Docket No. 95-CE-28-AD; Amendment 39-9472; AD 95-26-13

Airworthiness Directives; The New Piper Aircraft, Inc. (formerly Piper Aircraft Corporation)
PA28 and PA32 Series Airplanes

ACTION: Final Rule.

Figure 1

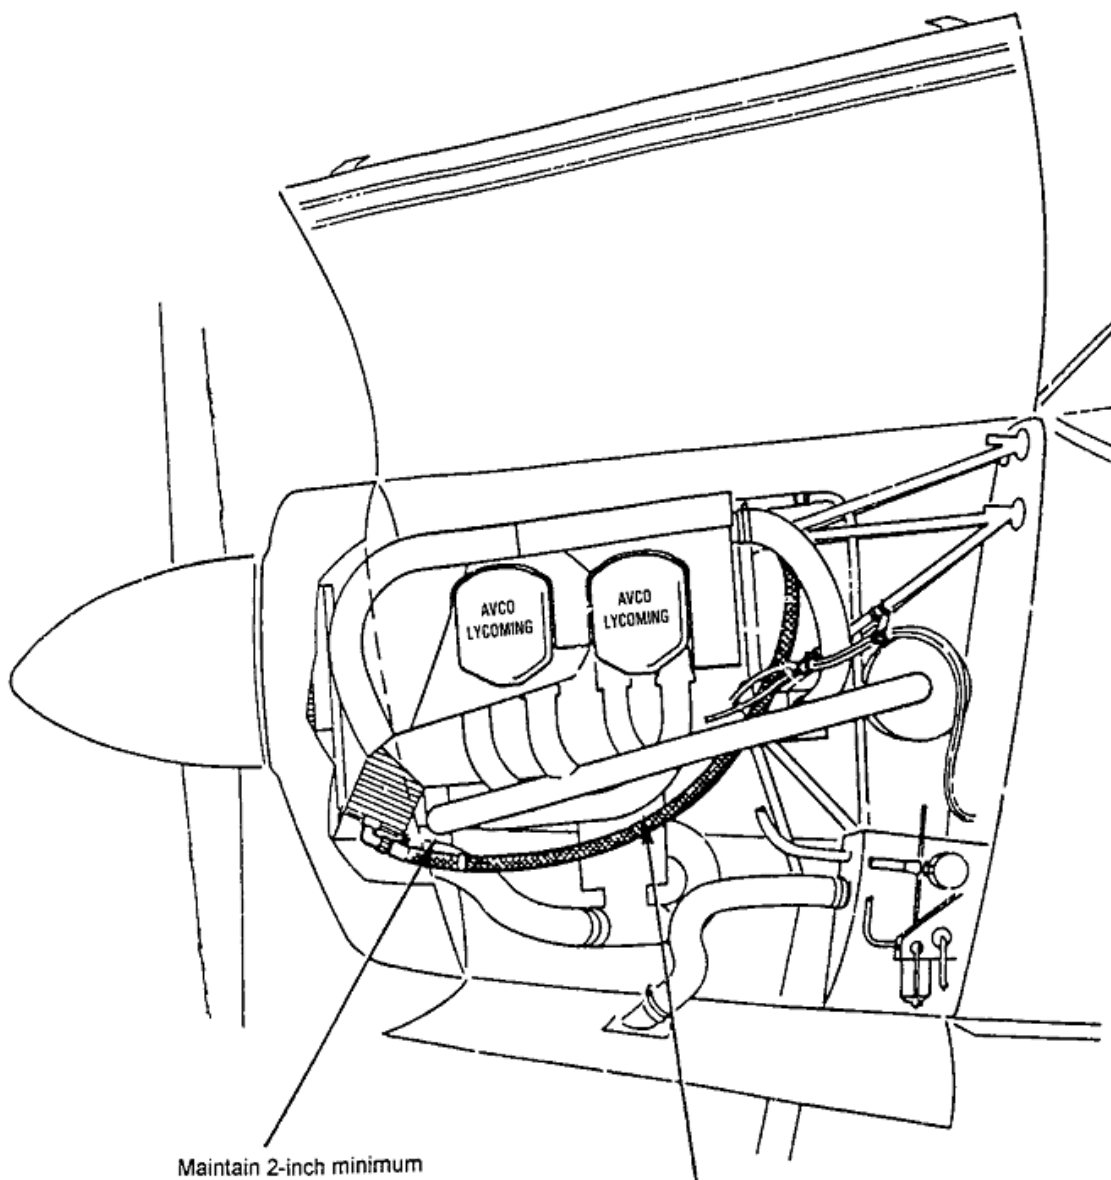
(2) On airplanes that have any oil cooler hose assembly mounted in the front of the airplane, ensure that the following exists, and, prior to further flight, adjust accordingly:

(i) The hose passes underneath and behind the electrical ground cable and in front of the lower of the two engine mount struts when the hose is routed to the rear of the engine; and

(ii) The hose is tied to the engine mount strut and a clearance of at least 2 inches exists between the oil hose and exhaust stack.

NOTE 2: Figure 1 of this AD relates to the conditions specified in paragraphs (a)(2)(i) and (a)(2)(ii) of this AD.

Maintain 2-inch minimum clearance between oil cooler hoses and exhaust stack in this area.

Maintain 2-inch minimum clearance between oil cooler hoses and exhaust stack in this area.
